Spokes response to consultation on Tram Route Cycle Safety Improvements (Phase 3)

This is a response to the consultation at

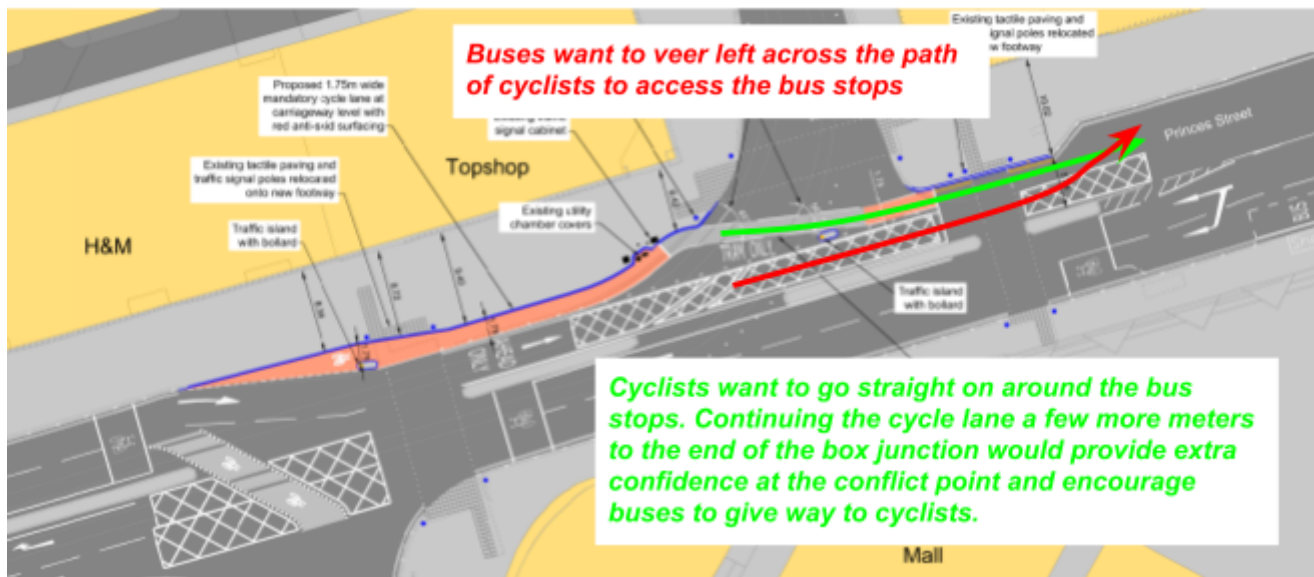
We recognise that this cycle lane results in some loss of pedestrian space, but there are valid reasons in this case. First, the footway is still as wide or wider than other sections along Princes Street and there are no bus stops cluttering this stretch of footway. Moreover, moving back the waiting area for the pedestrian crossing outside H&M/Topshop improves pedestrian safety by giving them a better sight line for vehicles continuing along Princes Street. The current waiting area protrudes into the carriageway and is aligned with the right turn lane from Princes Street into Waverley Bridge. This means that a pedestrian looking right is at risk of only focusing on this traffic and not realising that traffic continuing straight along Princes Street is actually further right in their peripheral vision. Introducing the cycle lane results in the waiting area being moved back and substantially reducing this risk.

With regard to the cycle lane itself, we're concerned that the cycle lane ends abruptly at the point where cyclists are trying to head straight on and buses are trying to cross their path to get to the bus stops. This conflict point is worse than it was before as the new cycle lane means cyclists are out the flow of traffic rather than in amongst it. We ask that you extend the cycle lane a little further east to help encourage buses to give priority to cyclists. We realise that extending the lane all the way to the East End junction is out-of-scope for this project (though it would be welcome in future), but even extending the lane a few more metres to the start of the bus stops would make a big difference.

Princes Street and South Charlotte Street

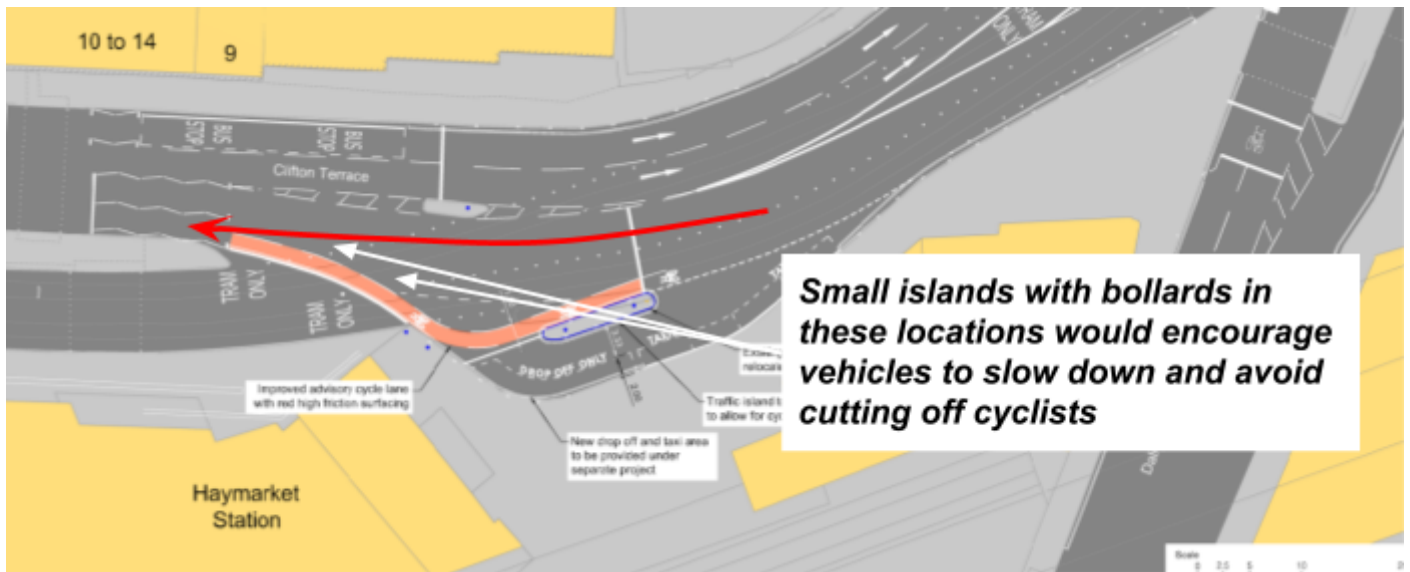
Reconfiguring this island is a small but nonetheless helpful improvement and we're pleased to see this.

It remains disappointing though that, on the other side of the road where Princes Street meets the West End junction, there is still no advance stop line for cyclists. This is a scary place to ride as there are 3 lanes of traffic. Additionally, the signalling is such that traffic can be queued in the right lane waiting to continue onto Shandwick Place and so cyclists may use the left lanes to undertake the queued traffic (and avoid the tram lines), only to get to the front of the queue and discover there is no ASL to take refuge in and they're stuck in the middle lane with traffic approaching from behind and nowhere to go.

We understand that there are complications with installing an ASL here due to tram signalling equipment, but we can't stress enough how helpful an ASL here would be. We hope that you'll reconsider this in Phase 4, or otherwise reconfigure the West End junction to make it safer for cyclists.
